OHIO TURNPIKE AND INFRASTRUCTURE COMMISSION

ADDENDUM NO. 2

**PROJECT NO. 58-18-02
TOLL PLAZA 180 EXPANSION
INTERCHANGE 180 - AKRON, MILEPOST 180.3
SUMMIT COUNTY, OHIO
OPENING DATE: 2:00 P.M. (EASTERN TIME),**

**MODIFICATIONS TO THE CONTRACT DOCUMENTS:
REVISIONS TO PLAN SHEET NOS. 9 AND 15 OF 75**

GRADING AND DRAINAGE PLAN
 STA. 10+00 TO END OF PROJECT

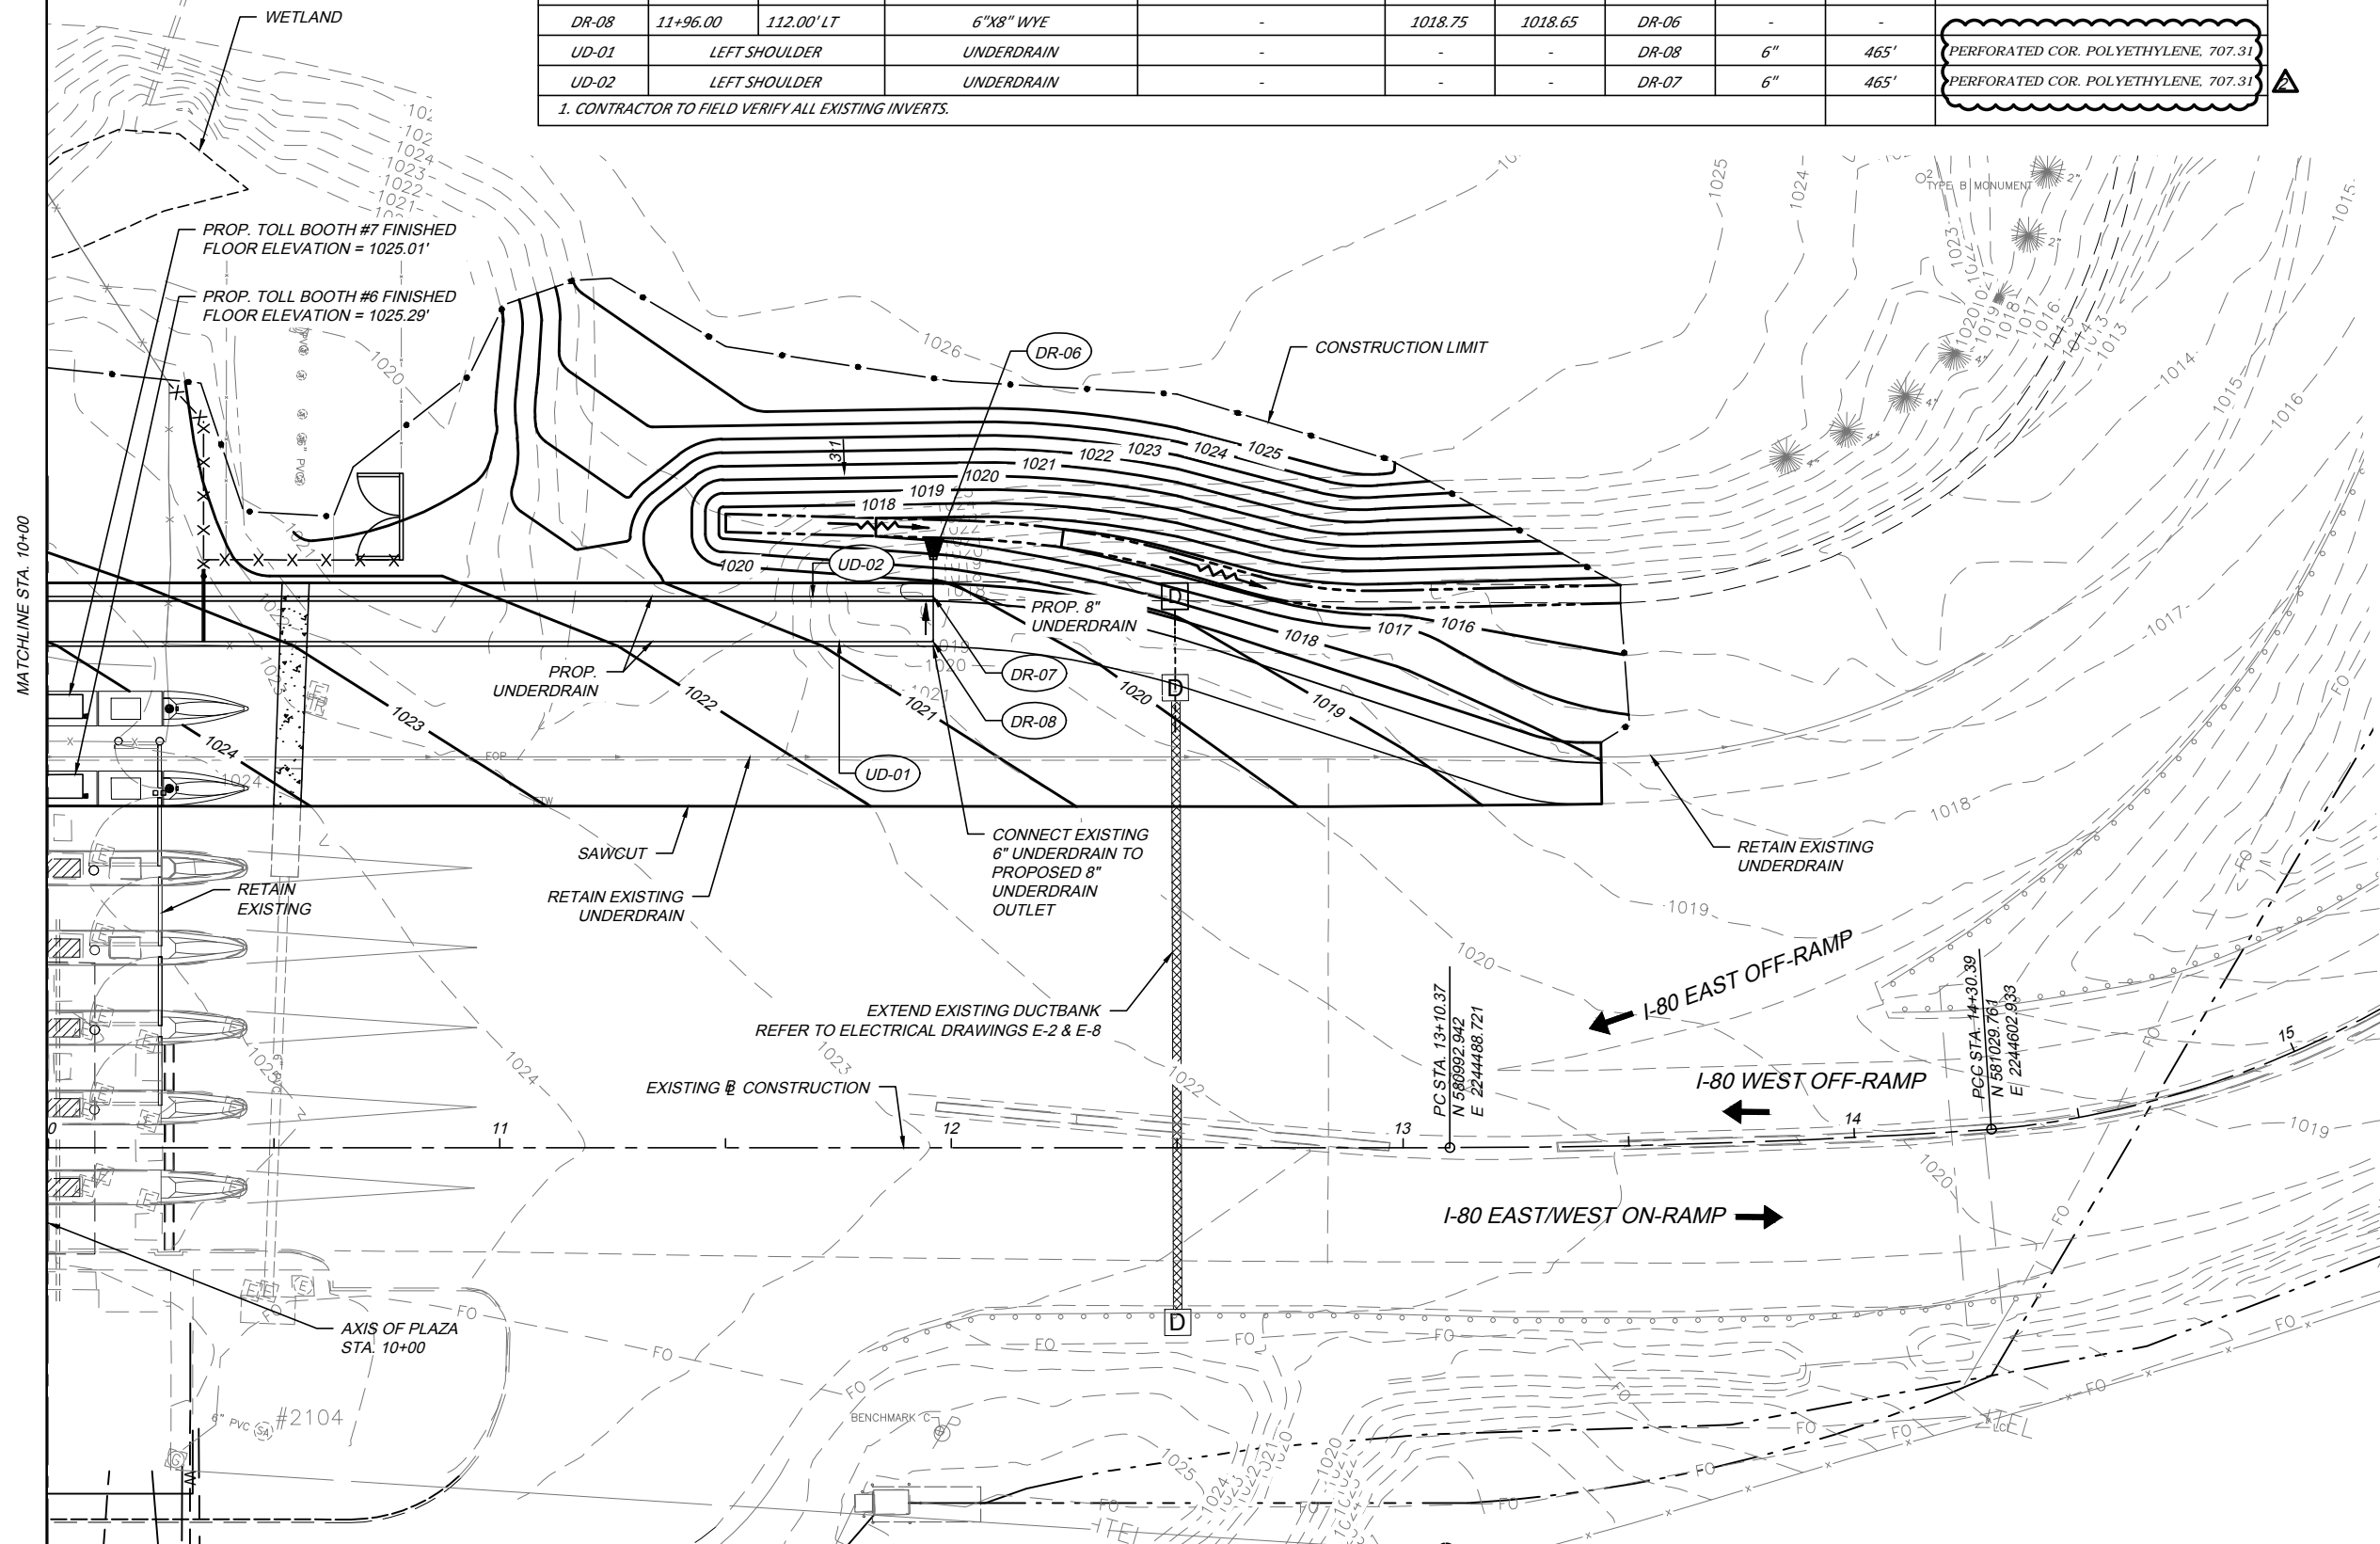
Q#14 The drainage schedule on sheet C-5 calls for the proposed underdrain as 6” perforated concrete pipe. In conversations with vendors, it appears that concrete pipe under 12” diameter is not readily available and perhaps not findable whatsoever. Please provide approved vendors of such underdrain or change the underdrain to a standard material via addendum.

A#14 The Commission lists ODOT 611 Type F pipe for underdrains. Contractor shall supply Type F conforming to ODOT 707.31. Plan Sheet No. 9 of 75 (C-5) has been revised and substituted in the Contract Documents through this Addendum No. 2.

ROOF DRAIN DETAIL
NOT TO SCALE

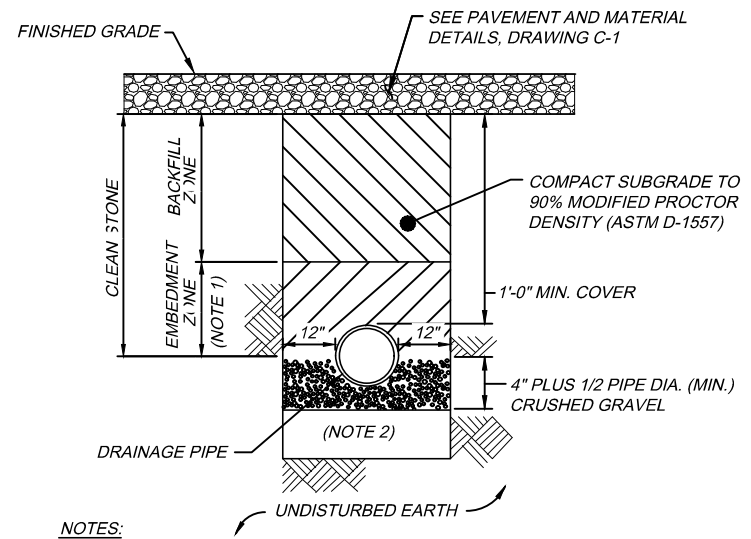
Q#15 Although sheet C-4 shows the proposed connection pattern between canopy and treadle drains, there is no detail provided illustrating the spouting/drainage system from the canopy to ground level. What is the material and size to be used for the spouting/drainage above ground? Please clarify and provide a detail in an addendum.

A#15 For clarification, Plan Sheet No. 15 of 75 (C-11) has been revised to include a Roof Drain Detail and is substituted in the Contract Documents through this Addendum No. 2.
